STAFF REPORT: APRIL 9, 2025 MEETING

APPLICATION NUMBER: HDC2025-00117

ADDRESS: 3470 CAMBRIDGE

SCOPE: REPLACE STEEL AND WOOD WINDOWS WITH VINYL-CLAD WOOD WINDOWS (WORK COMPLETED WITHOUT APPROVAL)

Façade

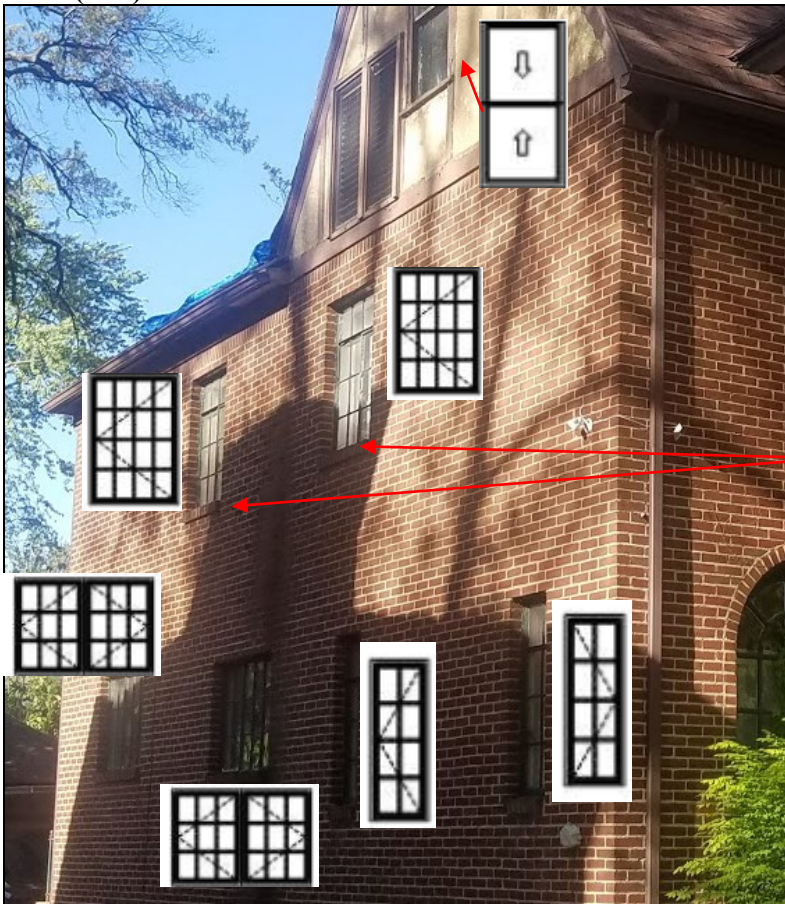
Staff compiled the photos below to compare the operation and design of the original windows and the proposed windows. The mock-up windows were copied from the applicant's window order. Windows are listed from left to right for each floor.

Above: The large square-shaped windows at the front of the house appear to have had central operating casements (2w/3h) between two sidelights (2w/3h), all of which were below a full width (4w/1h) transom.

Rear Wall

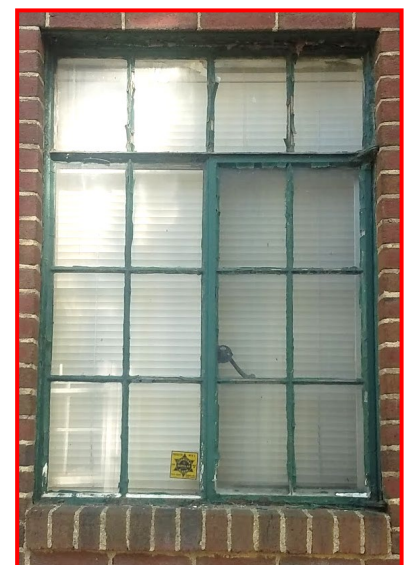
Below: The taller-than-wide windows on the side walls (and one opening at the rear-second floor) of the house appear to have had a single operating casement (2w/3h) with one adjacent sidelight (2w/3h), all of which were below a full width (4w/1h) transom.

Drawings from Pella's Lifestyle brochure.

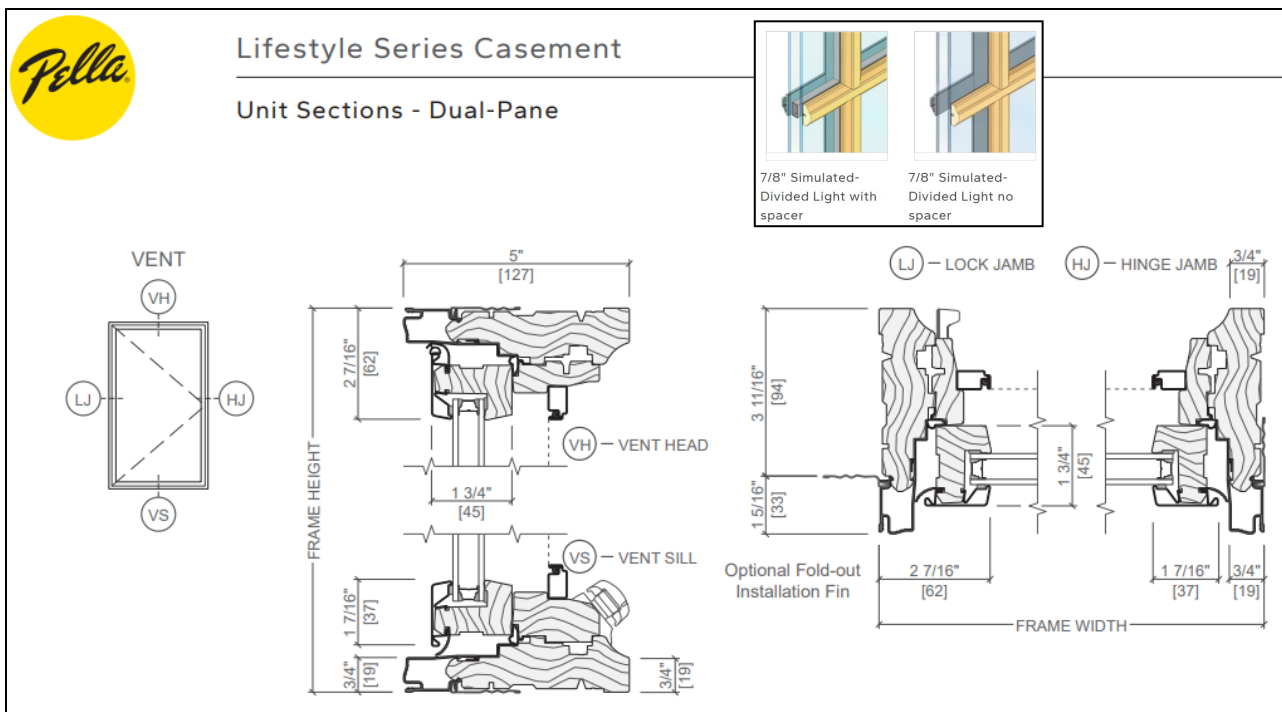
- Due to the difference in strength of steel and wood, the dimensions of the aluminum-clad wood frames and muntins/grilles will likely not match the thinness of the historic width and profile of the steel window frames, muntins and mullions.

- According to Pella's Lifestyle brochure, the casement window section shows the dimensions of the new casement windows would be as follows (coordinating with the symbols from Pella's location illustration):

Top Rail (VH)	2 - 7/16"
Bottom Rail (VS)	2 - 1/4"
Stile (LJ)	2 - 7/16" (left)
Stile (HJ)	2 - 1/4" (right)
Muntin	7/8" simulated divided light

- If the Commission considers the installation of the proposed aluminum-clad windows, the placement of the new windows should match the more deeply recessed location of the historic windows within the window openings. The depth of plane change between window and wall surfaces is an important feature on the elevations of the house and the current windows don't convey the same visual appearance.
